STAFF RECOMMENDATION 917 Caruthers Ave May 18, 2016

Metropolitan Historic Zoning Commission
Sunnyside in Sevier Park
3000 Granny White Pike
Nashville, Tennessee 37204
Telephone: (615) 862-7970
Fax: (615) 862-7974

Application: New construction - addition; Partial demolition
District: Waverly Belmont Neighborhood Conservation Zoning Overlay
Council District: 17
Map and Parcel Number: 11801026000
Applicant: John Root
Project Lead: Melissa Sajid, Melissa.sajid@nashville.gov

<p>Description of Project: The applicant proposes to demolish a non-contributing rear addition and to construct an addition to a contributing house.</p> <p>Recommendation Summary: Staff recommends approval of the project with the following conditions:</p> <ol style="list-style-type: none">1. If utilities are added or relocated, they shall be located on the rear façade or on a side façade beyond the midpoint of the house;2. The original window casings and historic brick on the historic home shall be retained;3. Lap siding shall be smooth-faced, and if siding exposure is not matched to that of the existing house, then it shall have a maximum reveal of five (5) inches; and4. Staff shall approve the final trim, windo

Figure 1: 917 Caruthers Ave, addition to be removed noted by arrow.

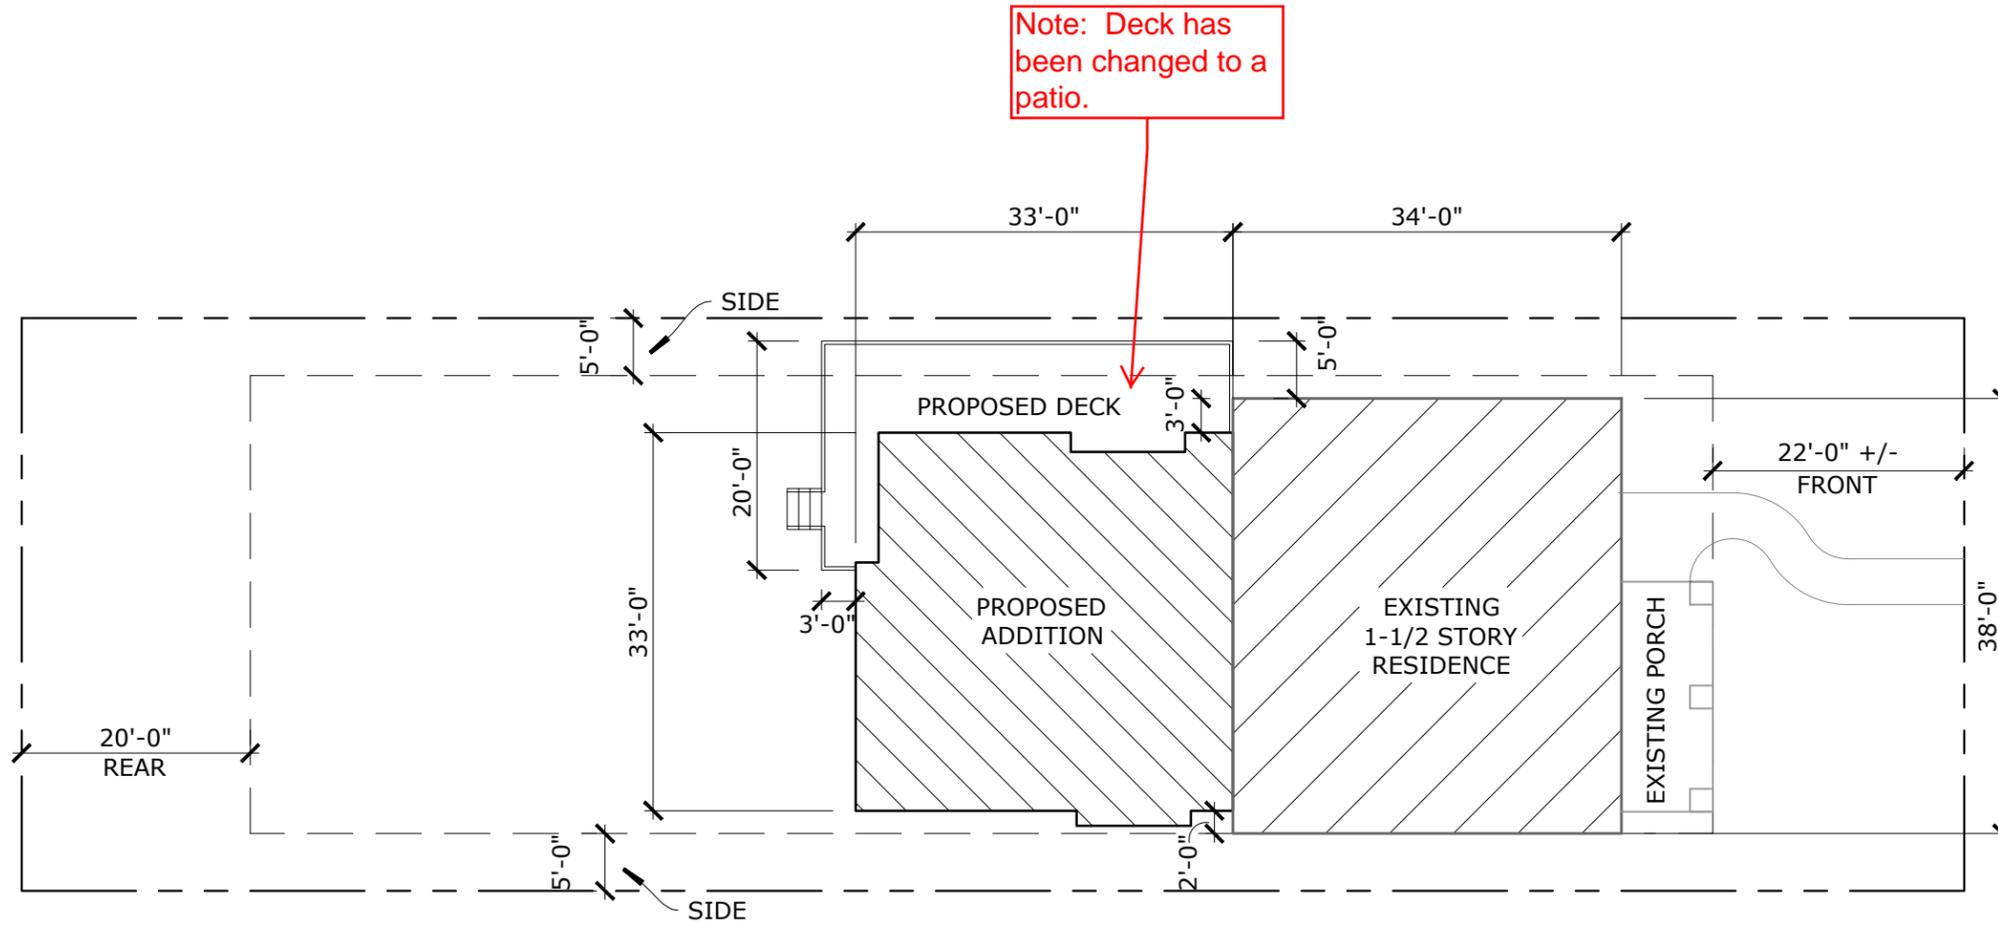
Partial Demolition: The application proposes to demolish an existing partial-width rear addition that is located on the right-rear of the house. The non-contributing addition added twelve feet (12') of depth to the house and one hundred and forty-four square feet (144 sq. ft.). Per the demolition plan, the right rear corner of the house is intact, and the plan proposes to keep it intact. Staff finds that the demolition of the non-contributing addition is appropriate as it is not original to the historic house.

As the plan proposes to remove a later addition, staff finds the proposed demolition meets Section V.B.2 for appropriate demolition and does not meet section V.B.1 for inappropriate demolition.

NORTH ELEVATION

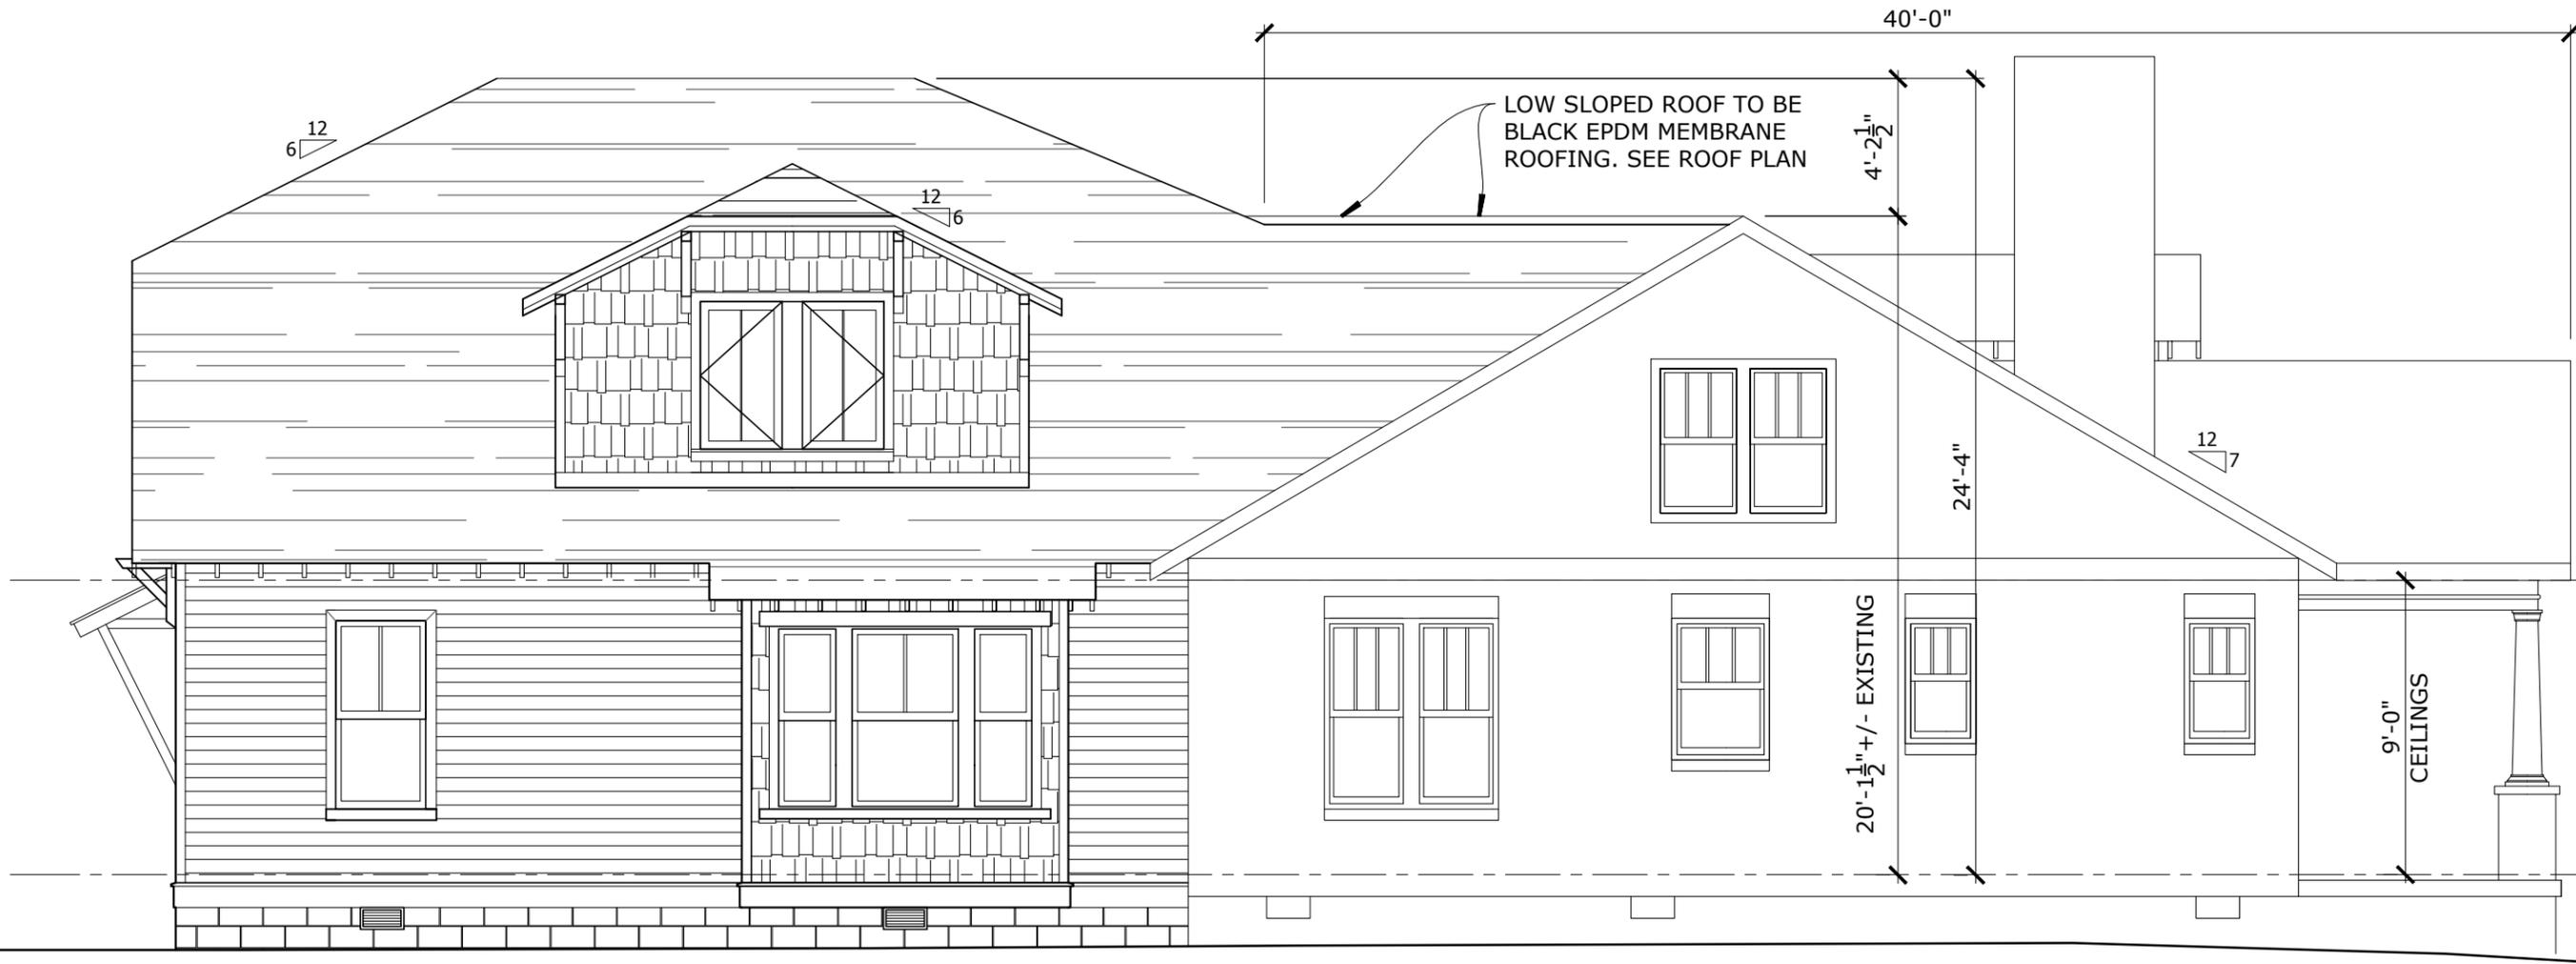
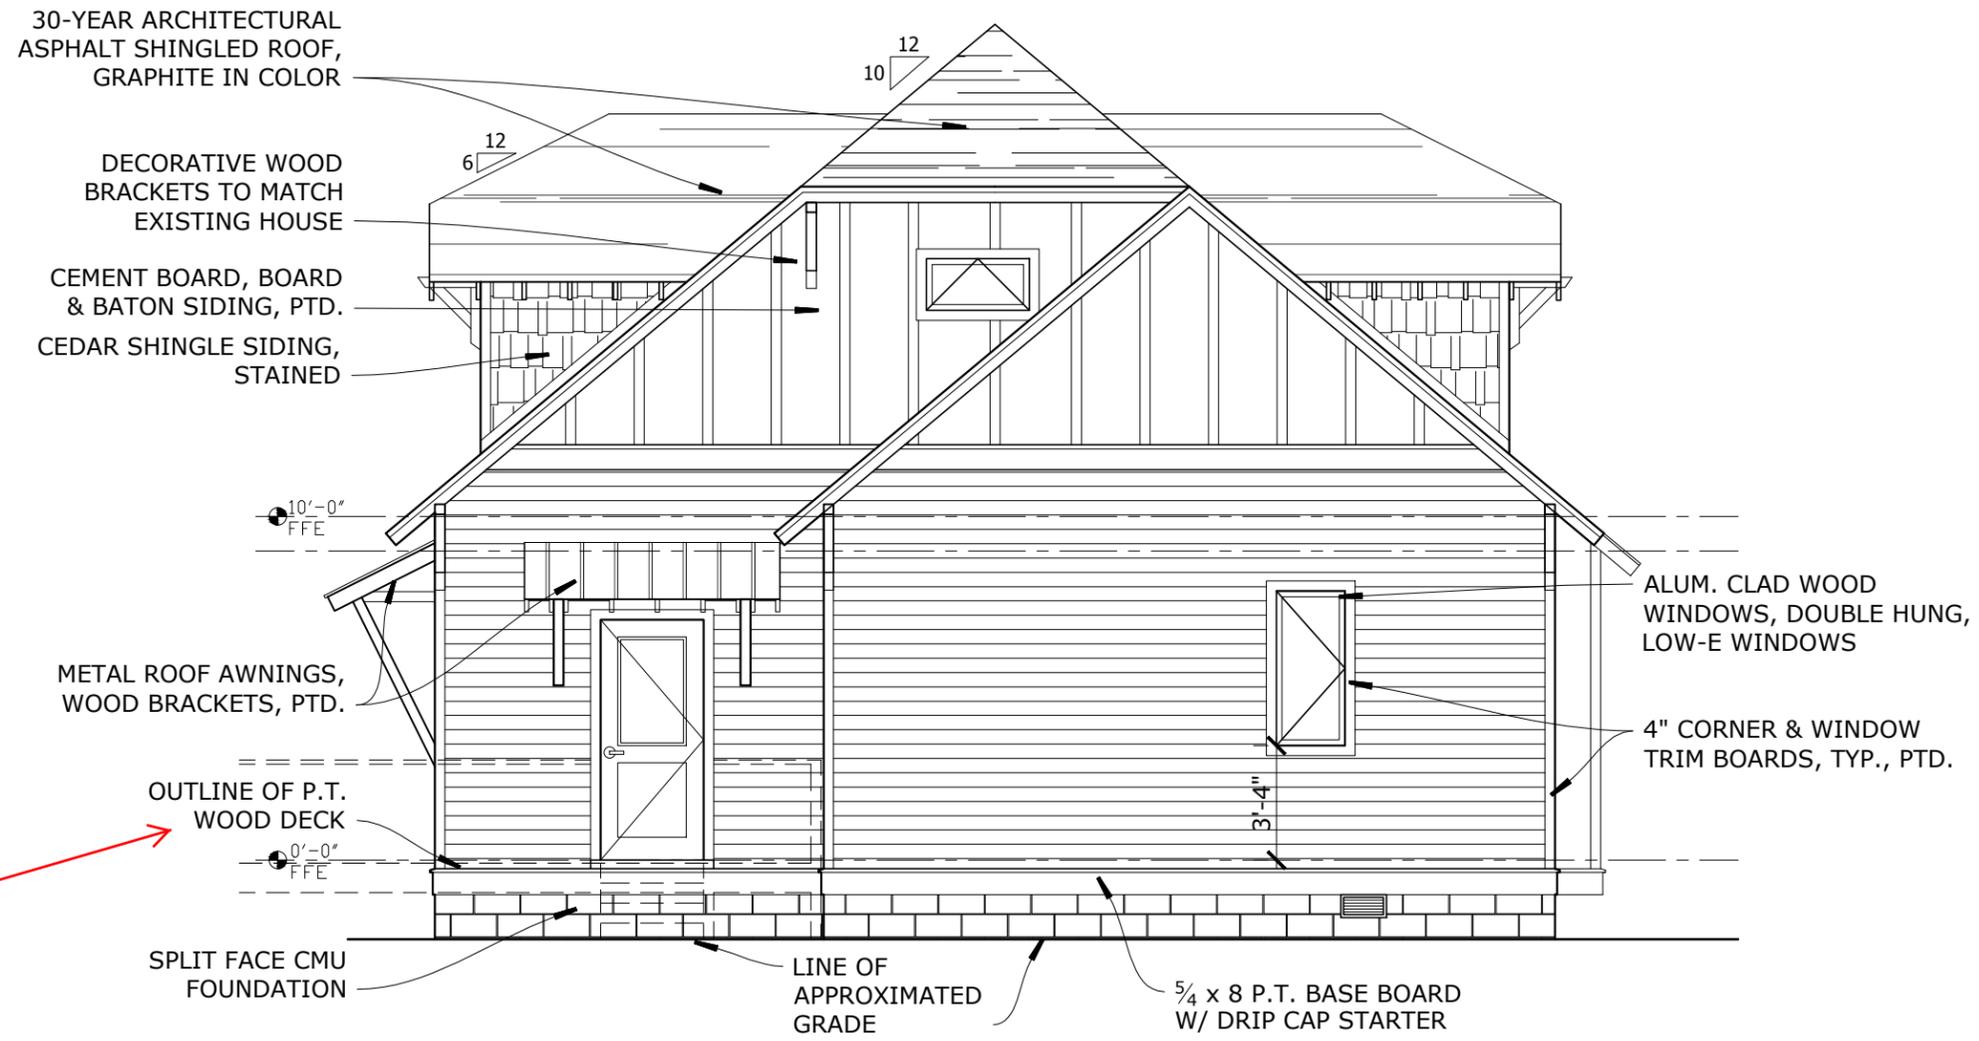
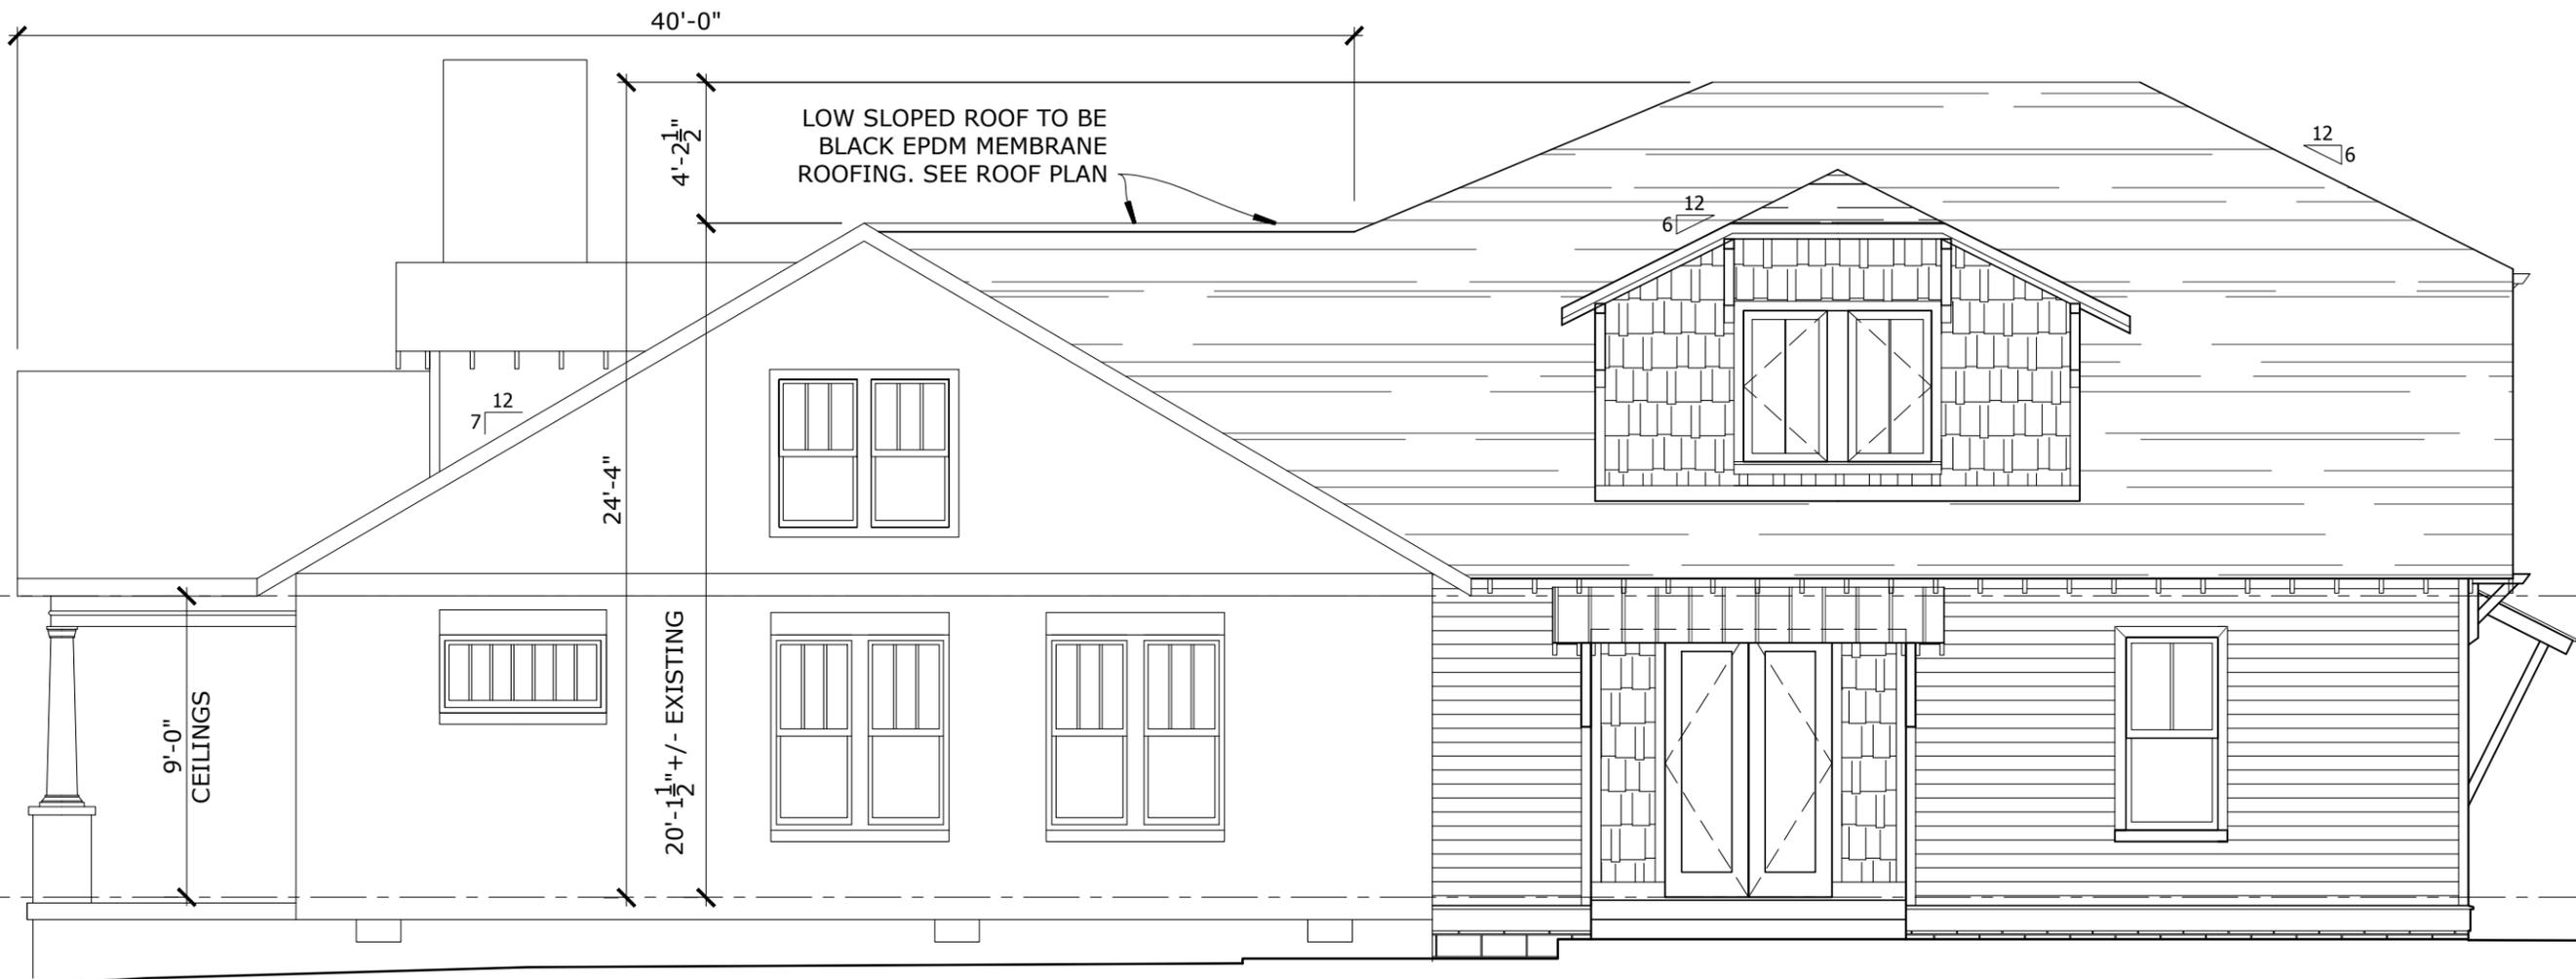
The addition has a maximum ridge height that is approximately four feet, two and one-half inches (4' 2 ½") taller than the ridge of the historic house. The addition is two and one-half inches (2 ½") taller than the maximum height per the design guidelines, but only approximately thirteen feet (13') of the width of the addition rises more than approximately two feet (2'). In addition, the additional height is located approximately

fifty-one feet (51') behind the front of the house, which is more than the forty feet (40') required by the design guidelines. Given the location of the additional height and the minimal amount of roof at the additional height that will be visible from the front, staff finds that the height of the addition is appropriate. The maximum foundation height is one foot, six inches (1' 6"), which is similar to the foundation on the existing house. Eave height on the addition is also similar to that on the existing house.

Materials: The addition is primarily fiber cement lap and board-and-batten sidings and cedar shingle siding. The roof will be primarily graphite architectural asphalt shingles. However, the low sloped portion of the roof that ties into the existing house will be black EPDM membrane roofing. Staff finds that the proposed membrane roofing could be appropriate as it will be used on a portion of the roof that is not visible from the front of the house and is necessary due to the low slope. The awnings over the rear and right side doors will be metal. The foundation will be split face CMU. Materials for the windows, doors, and trim are not known. Staff recommends including a condition that staff approve the final trim, window, and door selections prior to purchase and installation. With the condition that staff approve the final selection of the windows, doors, and trim, staff finds that the project meets Section III.D.

Roof form: The roof form of the addition is a clipped gable, with roof pitches of 6/12 and 10/12 that complement the existing historic house and help to minimize the visibility of the addition. The project meets Section III.E.

Proportion and Rhythm of Openings: The windows on the proposed addition meet the historic proportion of openings, being generally twice as tall as they are wide. There are

no large expanses of wall space without a window or door opening. Staff finds the project's proportion and rhythm of openings is consistent with Section III.G.

1. If utilities are added or relocated, they shall be located on the rear façade or on a side façade beyond the midpoint of the house;
2. The original window casings and historic brick on the historic home shall be retained;
3. Lap siding shall be smooth-faced, and if siding exposure is not matched to that of the existing house, then it shall have a maximum reveal of five (5) inches; and
4. Staff shall approve the final trim, window, and door selections prior to purchase and installation.
